RE: Revised URGENT MEDICAL DEVICE CORRECTION for 3.0T 6 Channel Flex Coil Fails Surface Coil
Temperature Test.
GEHC Ref#60888

URGENT MEDICAL DEVICE CORRECTION

RE: 3.0T 6 Channel Flex Coil Fails Surface Coil Temperature Test

Figure 3-55: Mode 2 – top coil with coil cable exiting toward patient's feet: left cable to MRI (A), to coil (B), and right cable to MRI (C).

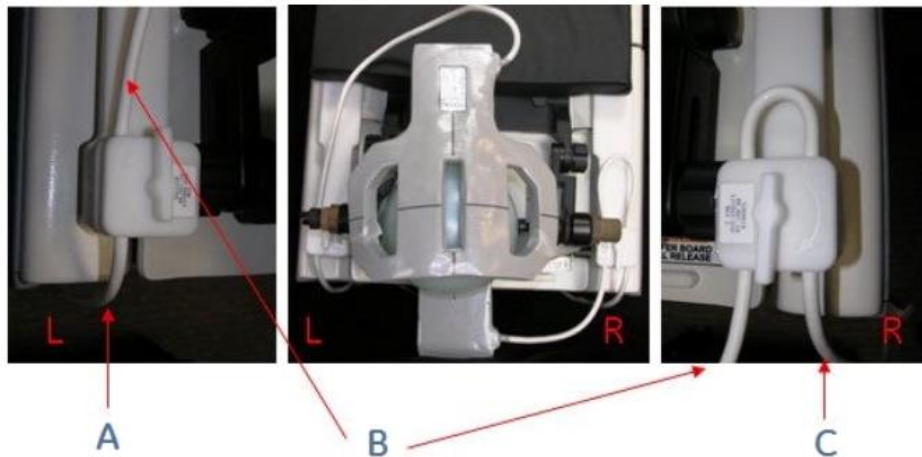
Coil overheating can occur when the device is used in Mode 2 setup. This could lead to a serious patient thermal injury. There have been no injuries reported as a result of this issue.

The issue is observed during the Mode 2 setup, as described in the “6-Channel Flex coil” section of the Surgical Suite operator manual (excerpts provided below).

1. Discontinue placing coil cables exiting toward the patient’s feet.
2. Discontinue use of Mode 2.

You can continue use of Mode 1.
